# Modele De Capital Ind. Ltd.(Unit-2)

27 June 2022

# Observations

**Structural design report not available**

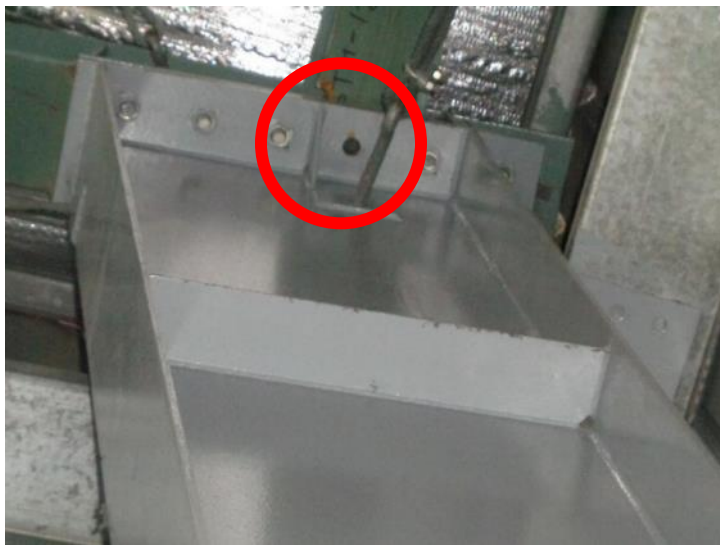
No design report is available for the structures (Shed-1, Shed-2, Shed-3, Shed-4 & Boiler room).

As per BNBC, every building or structure designed shall have its design documents prepared in accordance with the provision of Section 1.9.1. The design document shall include a design report, and a set of structural drawings, which shall be prepared in compliance with section 1.9.1.1 and section 1.9.1.2 of part-6, BNBC. However, design report was not available during inspection. The building engineer is required to prepare a design report in compliance with BNBC for all structures.

| Item No. | Observation                                                                                 | Recommended Action Plan                                                                                   | Recommended Timeline |
|----------|---------------------------------------------------------------------------------------------|-----------------------------------------------------------------------------------------------------------|----------------------|
| 01       | Structural design report not available. (All Structures)                                    | Building engineer is required to prepare design report in compliance with section 1.9.1.1 (part-6, BNBC). | 6-weeks              |

SC3

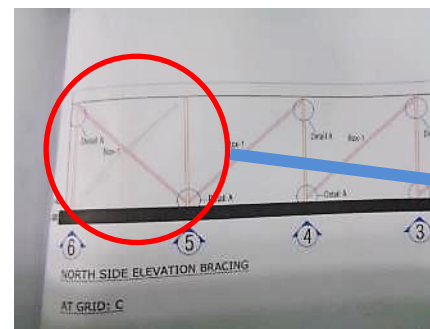
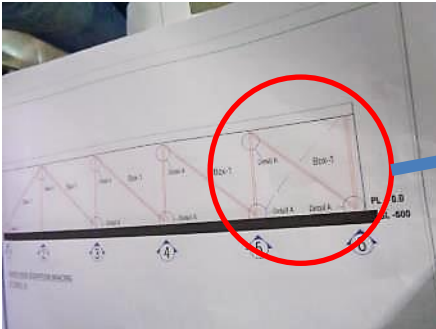
Steel column (SC-3) measured (F-120X8; W-195X8) instead of (F-135X8; W-210X8)

Mismatch observed in wall bracing arrangement

Discrepancy found between the as-built drawing and on-site condition. Building engineer is required to prepare accurate as-built drawing.

| Item No. | Observation                                                                  | Recommended Action Plan                                                                                              | Recommended Timeline |
|----------|------------------------------------------------------------------------------|----------------------------------------------------------------------------------------------------------------------|----------------------|
| 07       | Discrepancy between as-build drawing and on-site condition. (Shed-3)         | Building engineer is required to survey the structure & prepare accurate as- built drawings with structural details. | 6-weeks              |

## Foundation layout plan Shed- 4

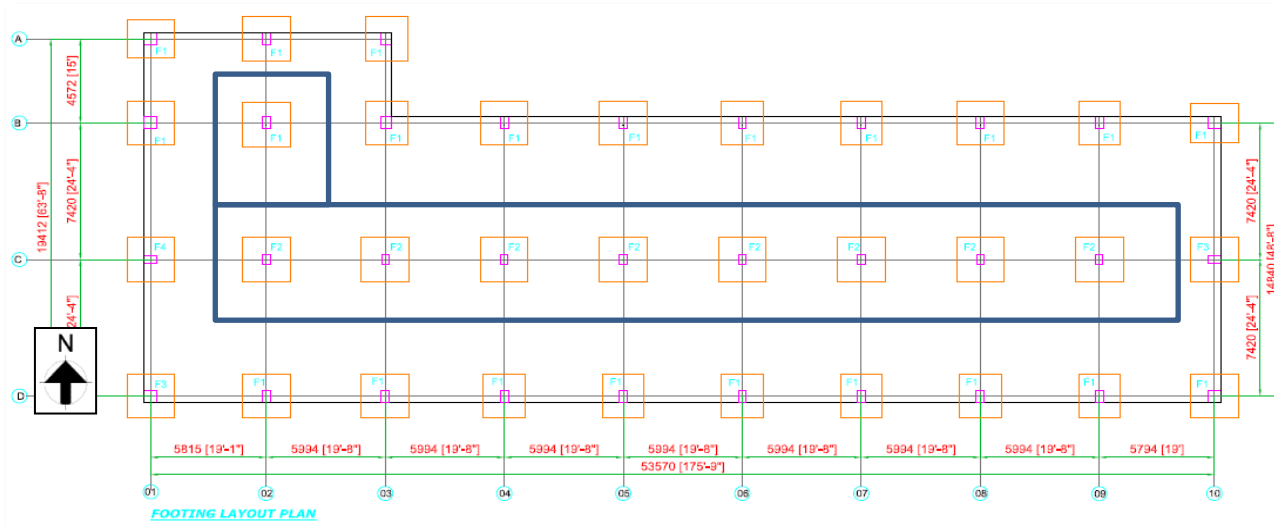
Cursory calculation indicates that the foundation stress exceeds the normal design limit for the internal footings. Considering prepared live load plan of 6 kPa and bearing capacity of foundation as per soil test report. The building engineer is required to review the design load and foundation stress.

| Item No. | Observation                                                                  | Recommended Action Plan                                                                                              | Recommended Timeline |
|----------|------------------------------------------------------------------------------|----------------------------------------------------------------------------------------------------------------------|----------------------|
| 08       | Bearing capacity of isolated footing below the normal design limit. (Shed-4) | Building engineer is required to review the design, load and foundation stress.                                      | 6-weeks              |
| 09       | Bearing capacity of isolated footing below the normal design limit. (Shed-4) | Verify and confirm the bearing capacity of the soil.                                                                 | 6-weeks              |
| 10       | Bearing capacity of isolated footing below the normal design limit. (Shed-4) | Carry out remedial works where necessary.                                                                            | 6-Months             |
